# San Marin High School Stadium Lights Project

Partially Revised Final Environmental Impact Report

SCH#2016082068

6	Responses to Comments on the Revised Draft EIR .....	53
6.1	Master Response: Light and Glare Impacts .....	54
6.2	Responses to Individual Comments on the Draft EIR .....	80

**Figure 1**  
**Mapped Bortle Scale**  
**over Portions of Marin, Contra Costa, San Francisco, Sonoma and Solano Counties**

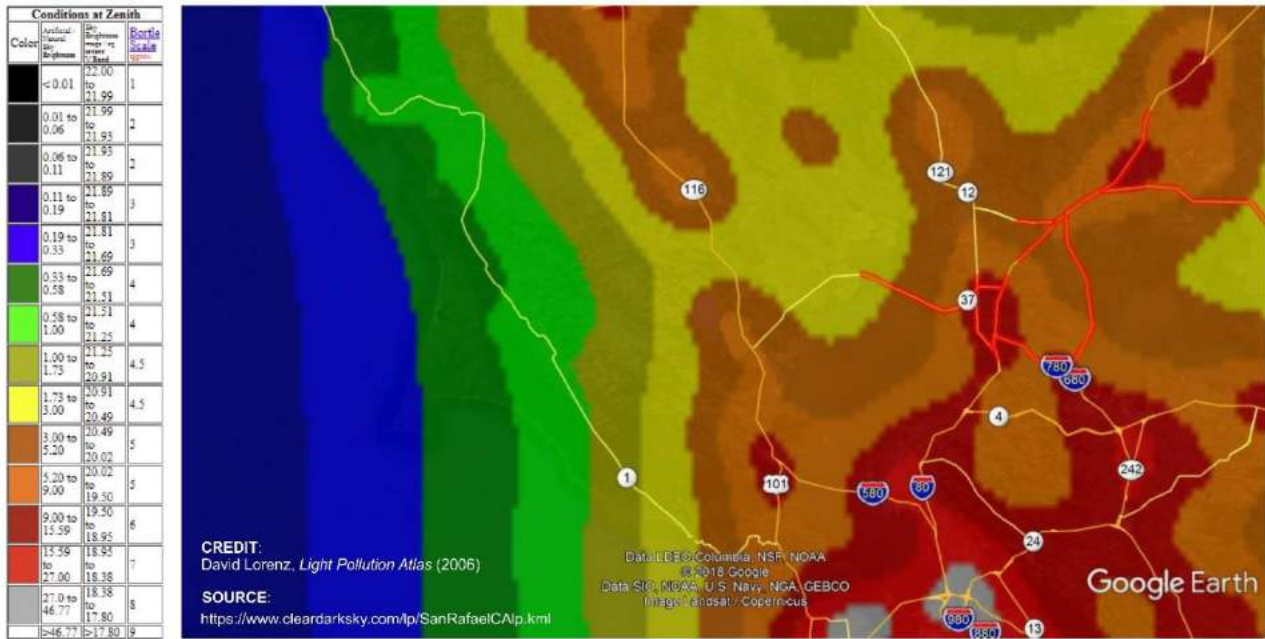
1. Factually, the statement that all of Marin County is mapped as an area today having a Bortle Scale of 5 is untrue. In Novato, heading west along Novato Boulevard, the Bortle Scale drops from 5<sup>+</sup> near U.S. Highway 101 to 5<sup>+/5<sup>-</sup></sup> near Novato High School to 4.5<sup>+</sup>, 4.5<sup>-</sup> and to 4. Figure 1 shows the variability of sky glow cross the region, and further shows that views of the nighttime sky are better on the urban fringe away from the urban core.

2. An area's sky glow and the Bortle Scale are related; indeed, it would be an onerous task to isolate the individual contributions of existing land developments to sky glow and assign responsibility or rank all the increments. This does not mean that individual projects cannot have individually minor yet cumulatively considerable impacts on the area's sky glow. It should be abundantly clear that the sky glow over a city or region is a cumulative effect.

**Figure 2  
Observer  
Locations  
and  
Viewing  
Lines  
of  
Sight**

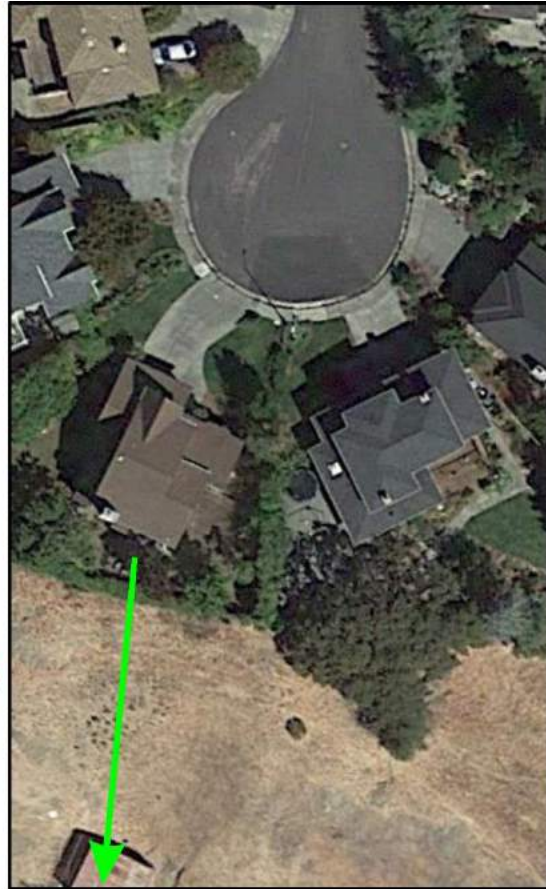
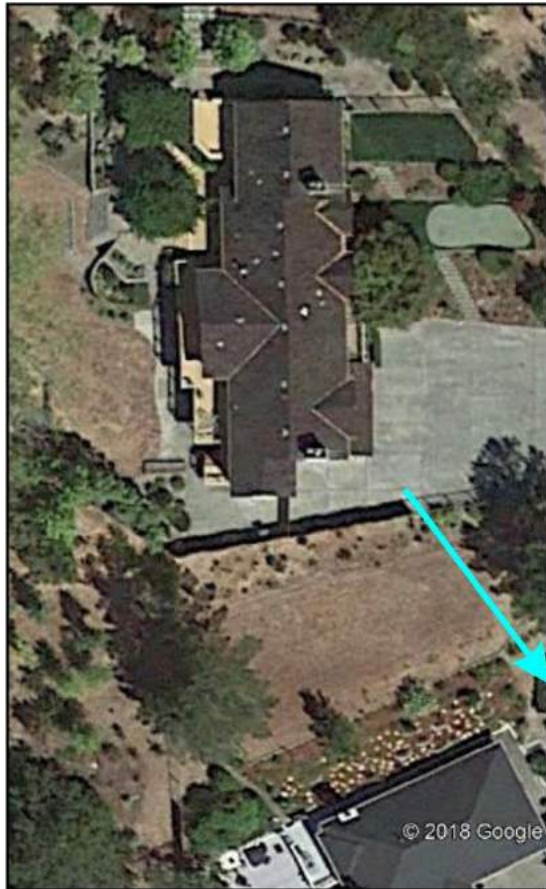
In Figure 4, Photos A and C demonstrate that glare depends critically upon the receiver’s elevation relative to the lights and also depends on the receiver’s location relative to the aiming line of the lights. Near the elevation of the stadium field, glare does not appear as pronounced as it is at receivers whose elevations are substantially below or substantially above the imaginary horizontal plane of the lights. Elevated receivers located to the northwest and west of the stadium will look down on unshielded ball-in-flight light sources will experience substantial glare from the upward-directed, ball-in-flight luminaires mounted on poles F6 and F7.<sup>3</sup>

The Revised Draft EIR should include photometric modeling at off-campus receivers, including the public trail receiver on Dwarf Oaks Trail represented in viewing vantage point of Revised Draft EIR Photo 3/7 (or, same as, Photo D1 here in Figure 5). Many off-campus receivers on both private and public land are elevated above the upward-directed ball-in-flight lights. The Revised Draft EIR should evaluate predicted glare relative to threshold limits for glare as outlined in Table 3 of CIE150: 2017.

**Figure 1**  
**Mapped Bortle Scale**  
**over Portions of Marin, Contra Costa, San Francisco, Sonoma and Solano Counties**

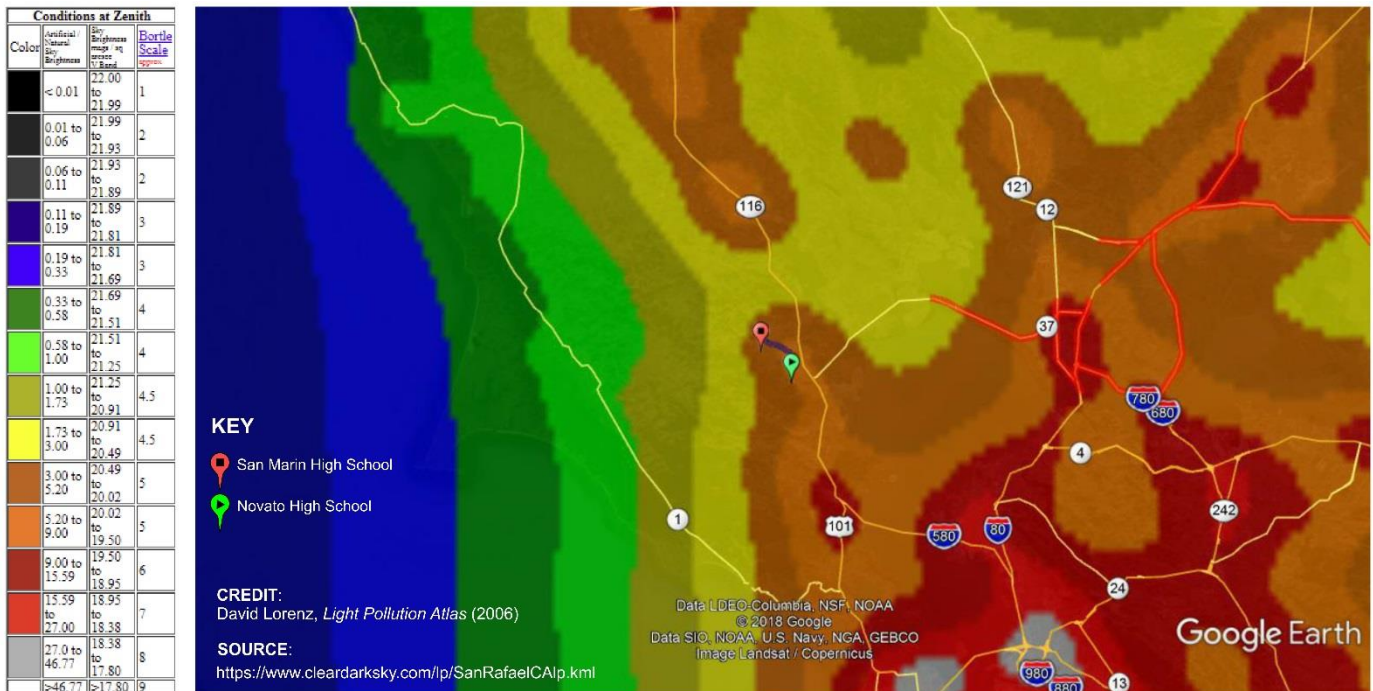
1. Factually, the statement that all of Marin County is mapped as an area today having a Bortle Scale of 5 is untrue. In Novato, heading west along Novato Boulevard, the Bortle Scale drops from 5<sup>+</sup> near U.S. Highway 101 to 5<sup>+/5</sup><sup>-</sup> near Novato High School to 4.5<sup>+</sup>, 4.5<sup>-</sup> and to 4. See Figure 1.

This is scarcely an analysis but rather an opinion. And, it is an opinion of the obvious. It should be abundantly clear that individual projects do not single-handedly create the sky glow seen over the region or the county. Collectively, however, they do create observable sky glow, and individually they do contribute to sky glow.

**Figure 2  
Observer  
Locations  
and  
Viewing  
Lines  
of  
Sight**

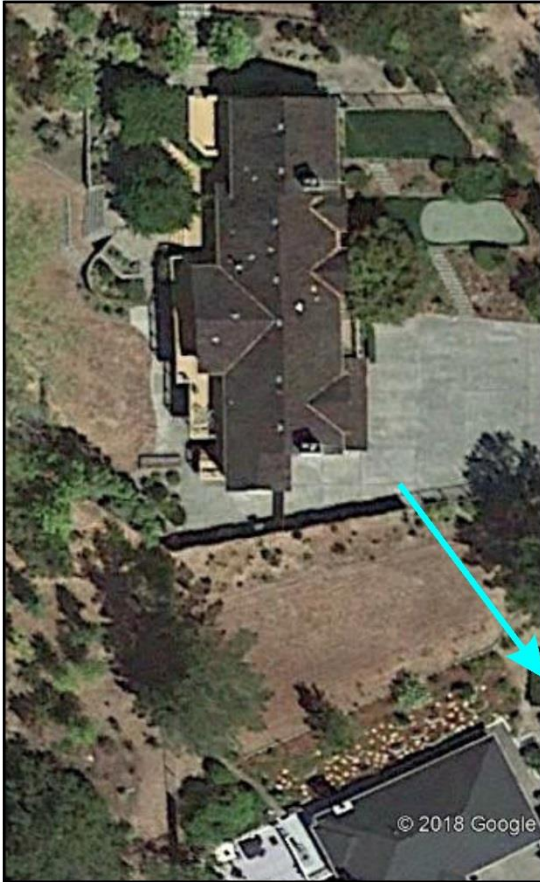
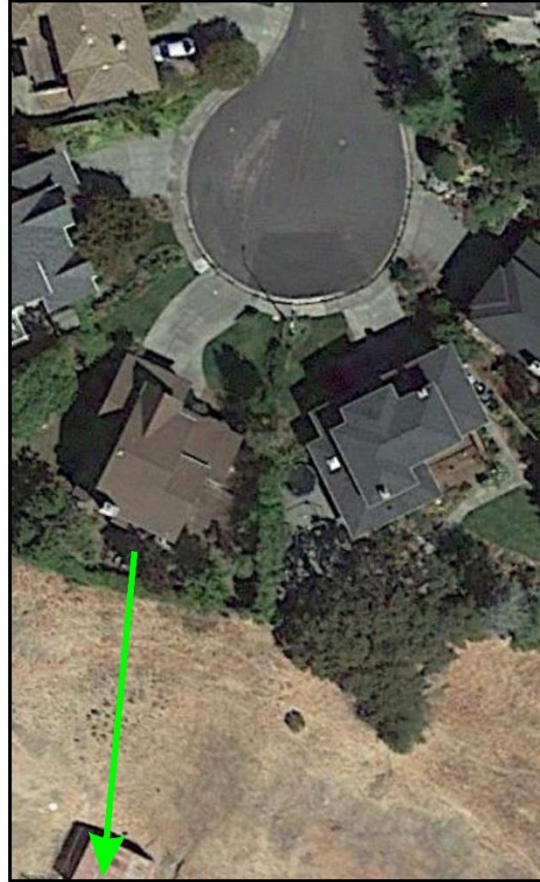
In Figure 4, Photos A2 and C2 demonstrate that glare depends critically upon the receiver's elevation relative to the lights and also depends on the receiver's location relative to the aiming line of the lights. Near the elevation of the stadium field, glare does not appear as pronounced as it is at receivers whose elevations are substantially below or substantially above the imaginary horizontal plane of the lights. Elevated receivers located to the northwest and west of the stadium will experience substantial glare from the upward-directed ball-in-flight luminaires mounted on poles F6 and F7.

The Revised Draft EIR should include photometric modeling at off-campus receivers, including the public trail receiver on Dwarf Oaks Trail represented in viewing vantage point of Photo 3/7 (or, same as, D1 in Figure 5). Many off-campus receivers on both private and public land are elevated above the upward-directed ball-in-flight lights. The Revised Draft EIR should evaluate predicted glare relative to threshold limits for glare as outlined in Table 3 of CIE150: 2017. The Revised Draft EIR in its discussion off-campus glare effects should delete reference to on-campus lux, in view of the fact that on campus lux is not predictive of off-campus glare.
